Dublin Cycling Campaign,
% Tailor's Hall,
Back Lane,
Dublin 8

R132 Connectivity Project - Non-Statutory Consultation

15th December 2020

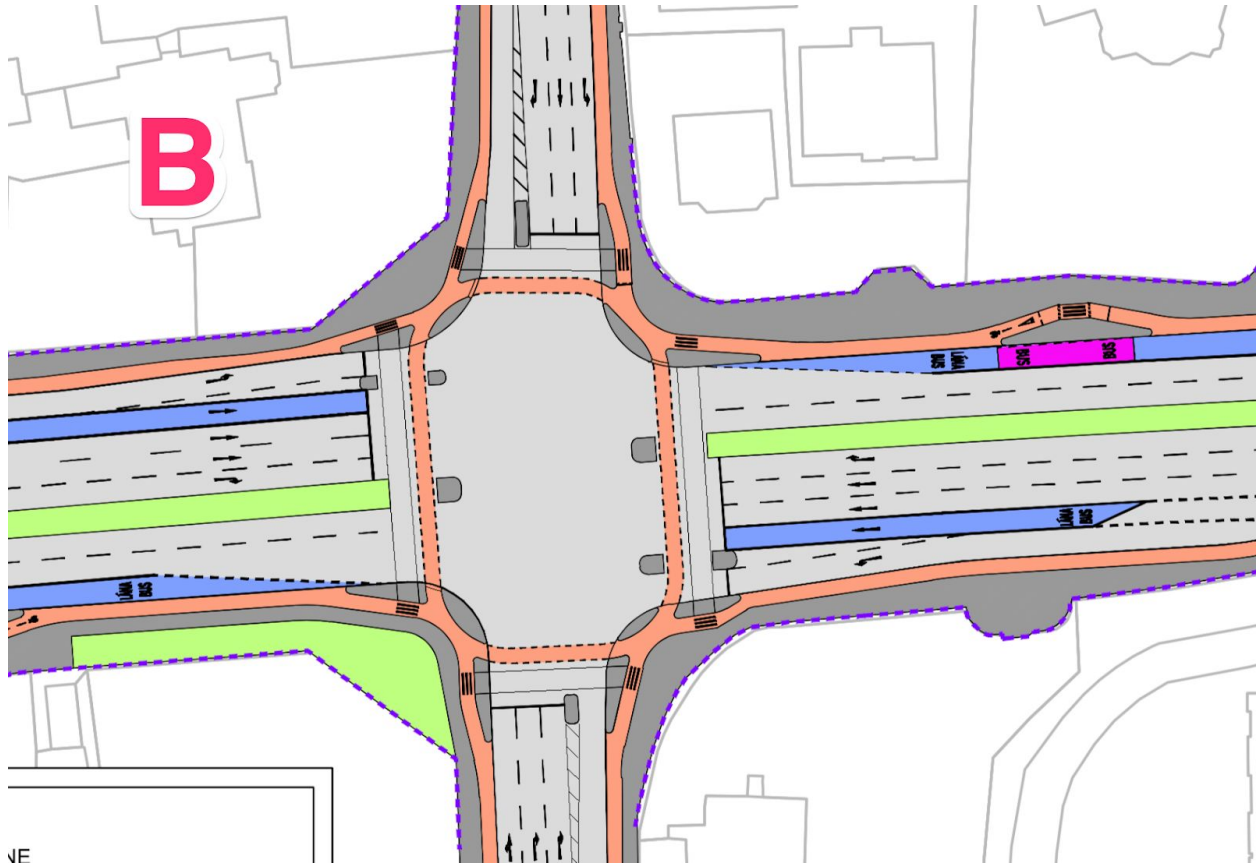
Our concern with junction design is how it designs in and forces conflict between cyclists and motorists and we have seen this in action at Lombard St in Dublin 2. In the proposed design motorists and cyclists proceed on the same green, save for the provision of a short “advanced green” that benefits only the people cycling who arrive at the junction during a “red phase”. For all other cyclists who are proceeding on green, they must contend with left turning traffic, drivers who are likely to be in slow moving columns and not expecting a cyclist to proceed on their left with right of way.

The small island at the junction can place the cyclist in the A-pillar or B-pillar blind spot of motorists leading to a dangerous situation of a driver turning left, physically unable to see the cyclists, not expecting them and believing they have right of way due to the green light phase. So-called “left hook” collisions and near-misses are a common experience of many people cycling in Dublin due to the dangerous design of, currently unsegregated, cycle lanes that filter them into junctions in this position. The proposed design while appearing to improve this through segregating a small part of the corner does not actually address the conflict-by-design issue and actually may increase the risk.

This type of junction, through its appearance of safety, may draw an inexperienced or low confidence cyclist into a false sense of security and, where many left-hooks are avoided by sharp reflexes, lead to an increased rate of collisions

Our proposals for addressing this are to adopt the learnings and practices, and not just visuals, of the Dutch style of design. There are other design options available such as cyclops which also offer more protection for cyclists and equal benefits for pedestrians.

DUTCH JUNCTION MOVEMENT SEQUENCE

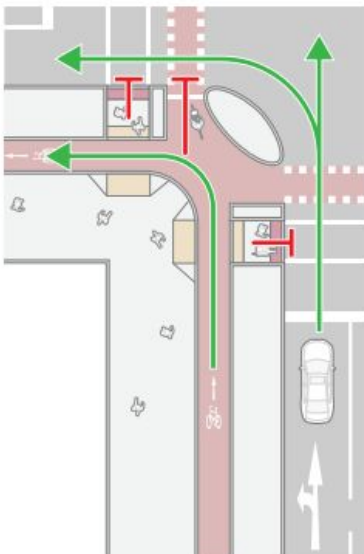
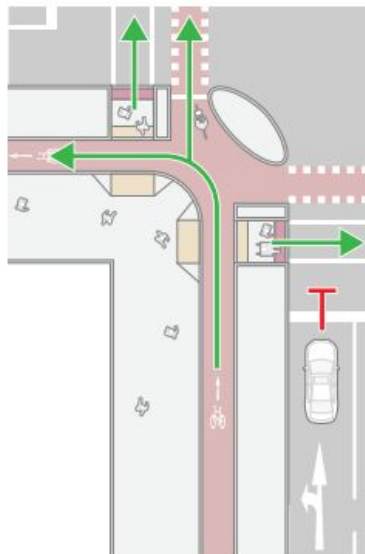
- 1 All motor traffic proceeds.
Straight ahead cycle & all pedestrian traffic is held.
Left turning cycle traffic proceeds.

- 2 All motor traffic is held.
All cycle and pedestrian traffic proceeds.

The Dutch junction style creates a shared pedestrian and cyclist phase, while cyclists are free to turn left at all times, similar to a pedestrian movement at a junction where only crossings are controlled. This requires the cycle lane to move inwards at the junction and create an island for pedestrians to use as part of their crossing - accessed via a tactile zebra crossing - shortening their signalised time / distance to cross.

In this design, cyclists and pedestrians cross together, and motor traffic waits / yields for both during crossing phases. At future dates, should the signalised crossings be safe to remove and replace with zebras, this design creates space for “shark teeth” holding zones where turning motorists have full line of sight of crossing pedestrians cyclists with no blind spots to worry about

FCC proposal for R132 junctions

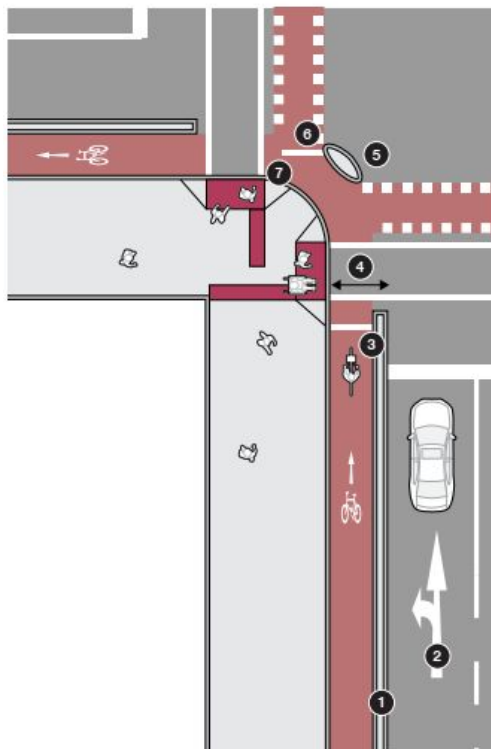
- 1 Raised kerb segregation
- 2 Left turning and straight ahead motor traffic lane
- 3 Stop line for cyclists
- 4 2.5m approx.
- 5 Corner protection island
- 6 Stop line for right-turning cyclists (depends on junction signalling)
- 7 Left turning cyclist must stop when pedestrian crossing is green.

DUBLIN JUNCTION MOVEMENT SEQUENCE (A)

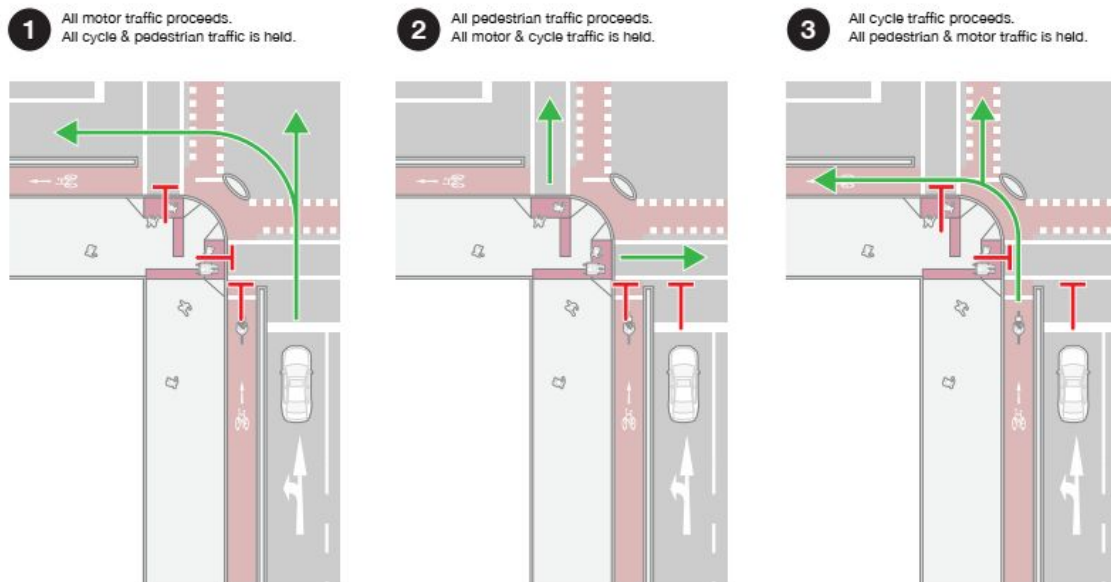
The only safe way to signalise a Dublin Junction is with 3 separate phases for pedestrians, motor traffic and cyclists and adds 3.7m (2 x 1.85m cycle lanes) to the pedestrian crossing distance during the green phase, as opposed to the Dutch junction which allows the pedestrian to cross the cycle lane at any time via zebra crossing to the island. This extra crossing time significantly impacts the flow of motor and cycling traffic and adds to waiting time for pedestrians who tend to be held even longer in an attempt to maintain traffic flow as a result of the 3 phases.

NOTE: Interrupting the cycle lane with the controlled pedestrian crossing will add an extra 5m to the pedestrian crossing span.

DUBLIN JUNCTION MOVEMENT SEQUENCE (B) (NOT SAFE FOR LARGE OR BUSY JUNCTIONS!)

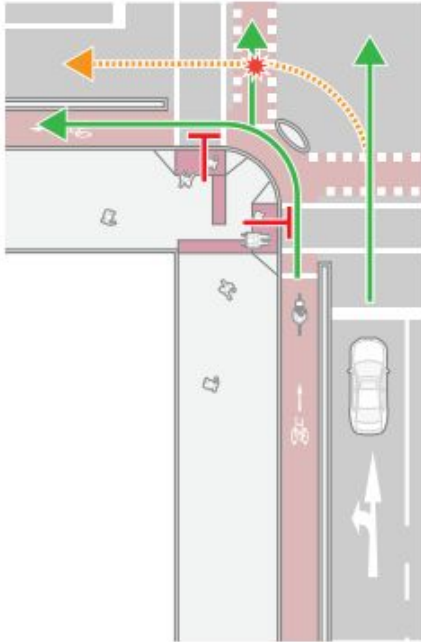
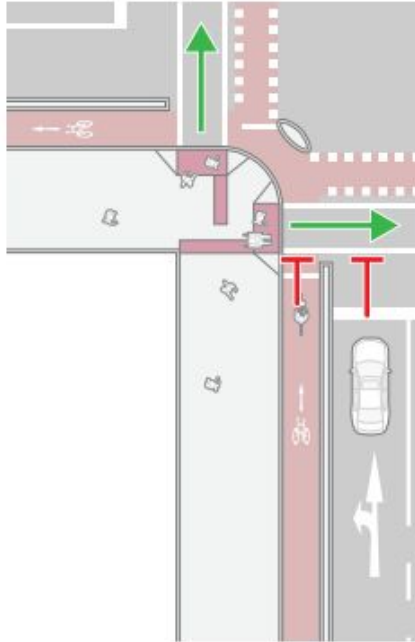
The unsafe option, which is often chosen as it facilitates smoother traffic flow, is the approach with 2 light phases (pedestrian then car+bike together) which places the cyclist in competition with motor traffic to move forward. We believe this solution is an unacceptable safety risk.

- 1** All motor & cycle traffic proceeds.
All pedestrian traffic is held.
High risk of conflict between cycle and motor traffic.

- 2** All pedestrian traffic proceeds.
All motor & cycle traffic is held.

Segregation of Cycle Lane via pencil bollards

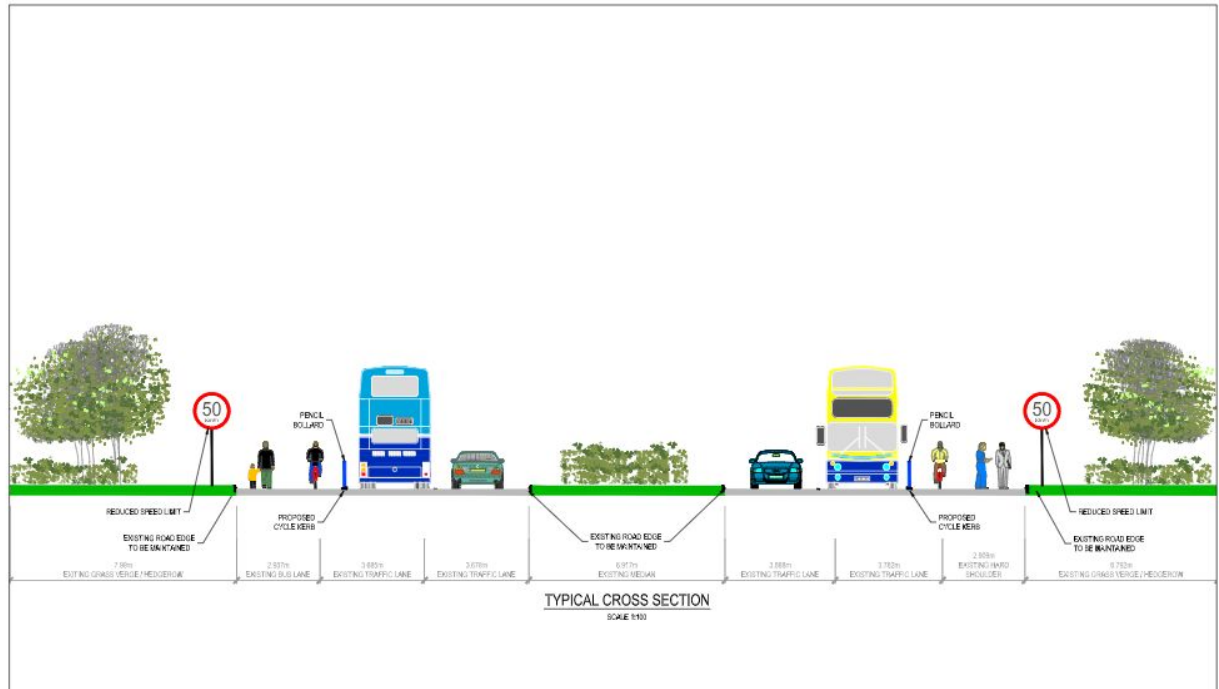
We would recommend that Fingal Co Co apply safer segregation at these sections using a kerb and some green space. There is a wide median in the centre of traffic that is not required for a road with a 50kph limit and could be relocated to the pedestrian / cycling side. Put a distance between the bike lane and Bus Lane. A bus passing at 50kph within 1metre is not pleasant for any cyclist and particularly children. Perhaps space can be taken from the median to allow a gap between bike lanes and traffic lane's, if this is not possible due to engineering requuireiemtns then we would suggest that existing verges be widened to achieve the same effect. This will also have benefits for pedestrians too. Something similar to the configuration on the Donabate Distributor road would be preferable

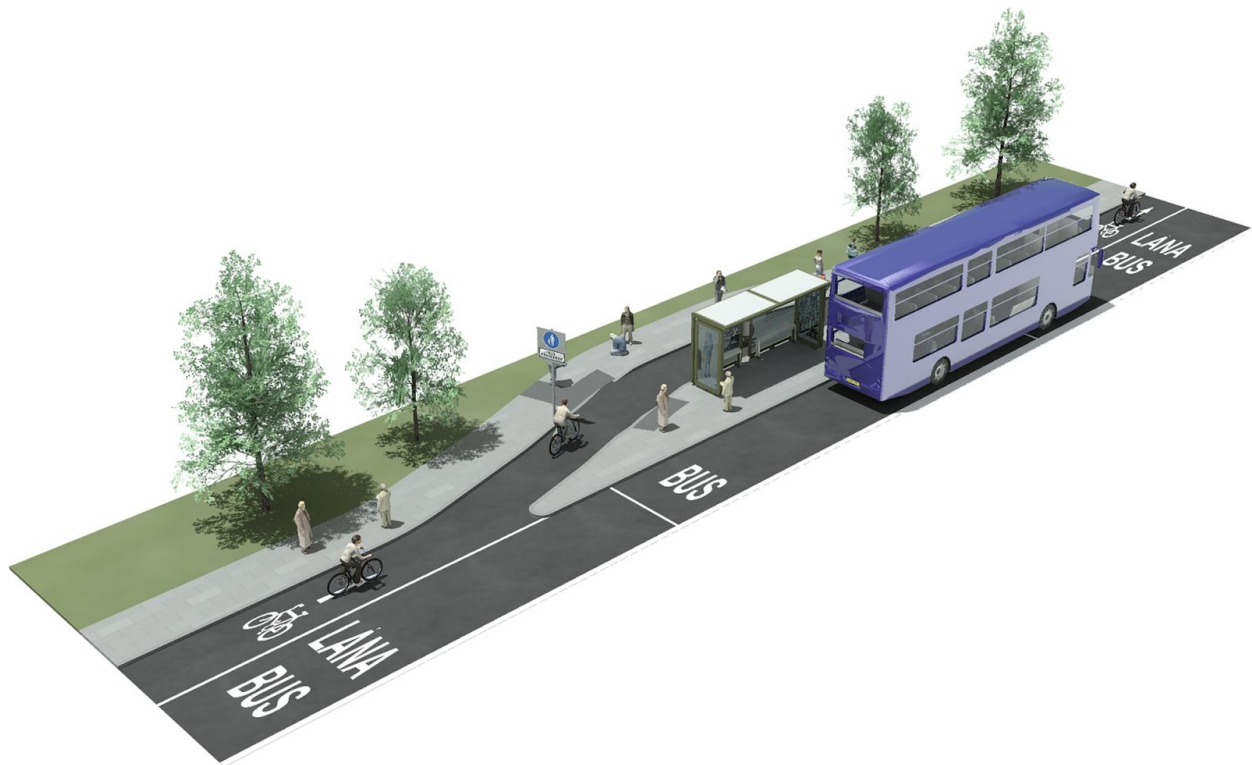
While the drawings are not detailed, they mention a typical layout will be a 1.85m footpath next to a 1.85m cycle lane with a kerb and possibly bollards. The footway and cycle track look flush which is not good for pedestrians - the footway should be higher than the cycle track so that

vulnerable pedestrians do not inadvertently stray onto the cycle track. A kerb on the inside and bollards on the outside of a cycle track will require margins of .25m and .5m respectively leaving a usable cycling space of 1.1m - aka: single file cycling. Cycling next to fast moving buses is not attractive either, especially if the road is wet so it would be good if they increased the horizontal separation as much as possible - and added some hedging - between the bus lane and cycle track.

Dutch Standard of 2.5m wide bike lanes should be considered. Current width of 1.85m will be difficult to overtake a bike, especially for wider bicycles such as handcycles, cargo delivery bikes, trailers etc. also as wheelchair and other mobility devices will generally use the cycle lanes we would really encourage more space to be allocated given the widths available. A particular call out is made to provide space for Cargo bikes given proximity of shopping centres
